**CONSULTATION PAPER ISSUED BY  
THE INFO-COMMUNICATIONS MEDIA DEVELOPMENT AUTHORITY**

**SECOND PUBLIC CONSULTATION ON THE REVIEW OF  
THE CODE OF PRACTICE FOR INFO-COMMUNICATION FACILITIES IN  
BUILDINGS (“COPIF”)**

**20 April 2018**

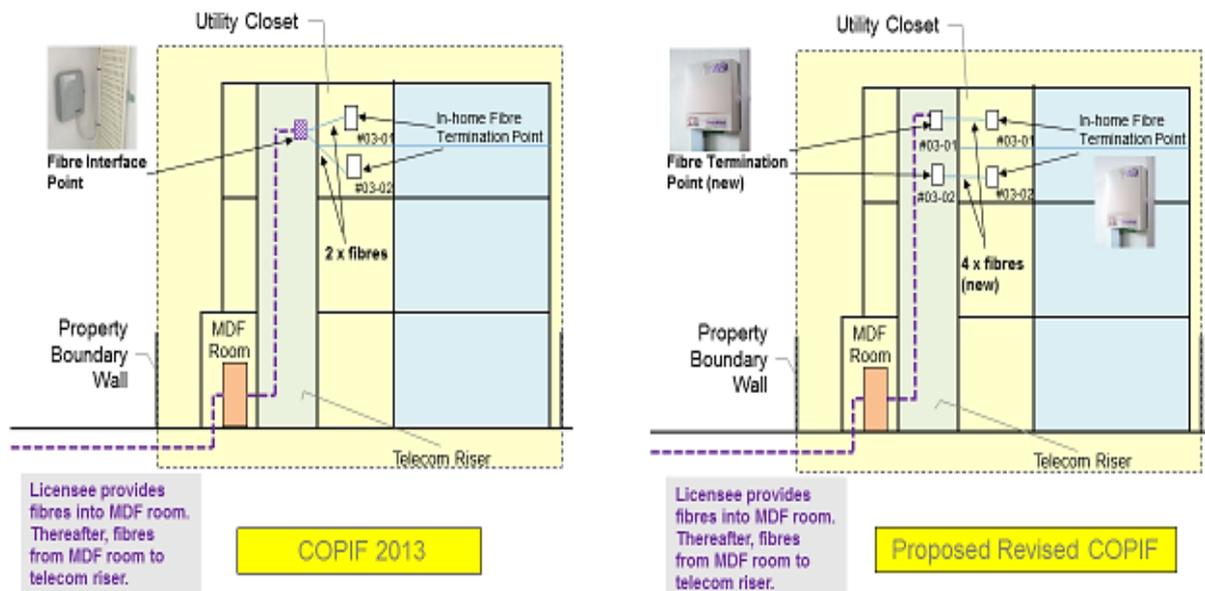
52. On the question of whether requirements of 2 sets of lead-in pipes (i.e. one set in vital services buildings and essential facilities and the other set at a different location) were sufficient, along with whether the 2 sets of infrastructure should be mandated or not, all respondents agreed that it was sufficient to have 2 sets of lead-in pipes and 2 sets of infrastructure, with most respondents in support of 2 sets of lead-in pipes and 2 MDF rooms and telecom risers. Also, the general view was that it should be left to the developer's/owner's discretion to decide if they require building resiliency needs to be met, unless it involved a vital services building. In essence, IMDA will require diversity provisioning and resilience to be catered for buildings housing vital services (a non-exhaustive list of examples of such buildings has been provided in the preceding paragraph). Therefore, such buildings will need to be provided with 2 sets of lead-in pipes and 2 sets of infrastructure (2 MDF rooms and telecom risers). For other buildings not included in the list of examples and not housing such vital services, IMDA agrees with respondents' comments that the

53. In addition, where diversity is required and therefore 2 sets of MDF rooms and risers are to be provided, respondents commented that the additional MDF room must be at a different location with the respective lead-in pipes leading to different roads. IMDA agrees that network resilience will be enhanced with positioning at different roads/locations. However, IMDA's view is that the second set of diversity requirements need not be equal to the first set provided by the developer/owner. Being mindful of resource allocation and avoidance of wastage, and as the requirements for the additional MDF room meant for diversity are to be provided over and above the allocated specifications, IMDA will not require that the second MDF room for resiliency be of the same size as the first MDF room. For the avoidance of doubt, however, the second MDF room is required to be of the minimum size as set out in the requirements for non-residential buildings under the Proposed Revised Code, i.e. minimum dimensions of the MDF room shall be 3m (length) by 2m (breadth) by 3.5m (height). Specifically, for larger developments more than 2,000m<sup>2</sup>, the second MDF room need not be of the exact scale or proportions as the first one to be provided by the developer/owner, as long as it is of the stipulated minimum dimensions, at a different location and offers redundancy options. Building developers/owners are encouraged to cater for the abovementioned, in view of resiliency purposes. More details on the network and service resilience and infrastructure requirements are set out further in the Proposed Revised Code.

developer/owner may decide if they require such diversity provisioning and cater accordingly.

**Diagram B: Air-blown fibre microducts for non-residential developments**

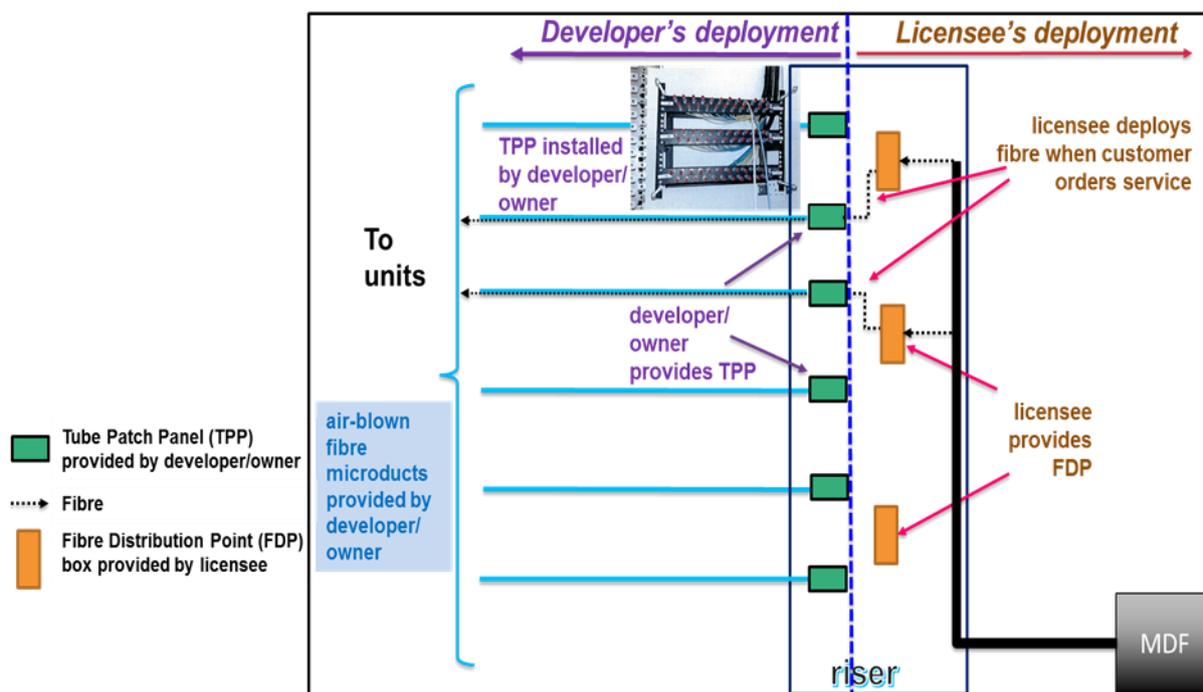
63. Alternatively, if fibre need not be pre-installed, IMDA has proposed other facilities such as 2-way air-blown fibre microducts ("**ABF microducts**") as another means of pre-installation of infrastructure to facilitate service provisioning in non-residential developments.

64. IMDA has considered that due to the nature of non-residential developments which are more frequently re-configured in layout when tenants move in and out of units on a short to mid-term basis, this ABF microducts solution does not require a fixed location of FTP as the ABF microducts terminating in the units will be coiled above the ceiling in the units. Concurrently, IMDA is also recommending for the ABF microducts, which are to be provided by the developer/owner, to be terminated in appropriate frames with brackets in the riser at each floor and to allow Licensees to determine the amount of fibre to deploy in the risers. Further, developers/owners need not worry about fibre repairs which they are probably unfamiliar with.

65. The adoption of 2-way ABF microducts is thus recommended due to faster, simpler provisioning as fibres are blown direct to the units. More importantly for the developers/owners, such provisioning will be less inconvenient to tenants while allowing flexibility in determining FTP location. There would also be a lower likelihood of wastage of resources. Even if a unit is served by multiple Licensees, there is likely to be easier maintenance and speedier repairs as Licensees are not dependent on one another. As such, IMDA is requiring 2-way ABF microducts to be provided by the developer/owner from the riser at each floor to every unit in new non-residential developments and this is included in the Proposed Revised Code. See Diagram B.

**Diagram C: Proposed re-configuration of in-home co-axial cabling**

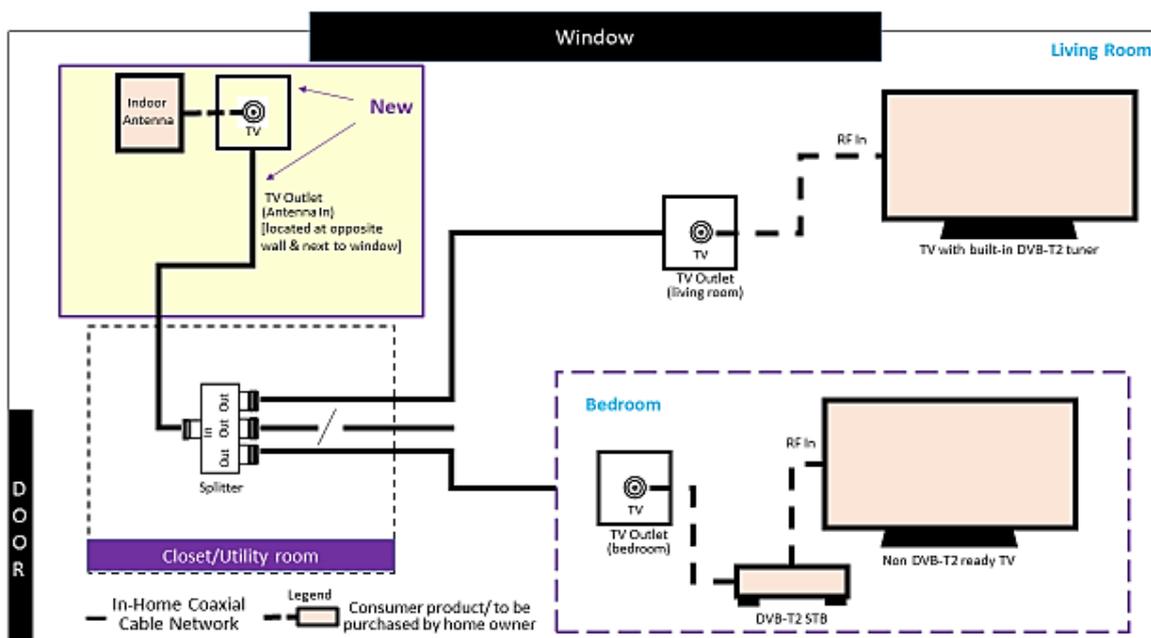
73. It has recently been brought to IMDA’s attention that StarHub Cable Vision has plans to cease its Hybrid Fibre Co-axial (“HFC”) infrastructure installation to new residential buildings, come May 2018. It follows that IMDA will need to assess whether the existing co-axial cabling obligation ought to be retained or modified in the Proposed Revised Code.

74. IMDA has explored the possible uses and modification of the co-axial cabling for Free-To-Air (“FTA”) TV, in support of Mediacorp Digital TV (“DTV”), to allow residential units to continue the use of co-axial cabling for the distribution of DTV signals. One of the options that IMDA has considered is to allow the home owners to attach an antenna to one of the newly-required TV inlets to distribute TV signals within the home. With this in mind, IMDA is seeking feedback on the proposed re-configuration or modification to the in-home co-axial cabling to support distribution of DTV signals within the residential unit as prescribed in the Proposed Revised Code.

75. IMDA proposes the solution, in support of Mediacorp’s DTV, as illustrated in Diagram C with the black dotted lines representing a possible connection of indoor antenna, set-top box and TV set to television outlets and connection points for end-users’ in-home co-axial cabling.
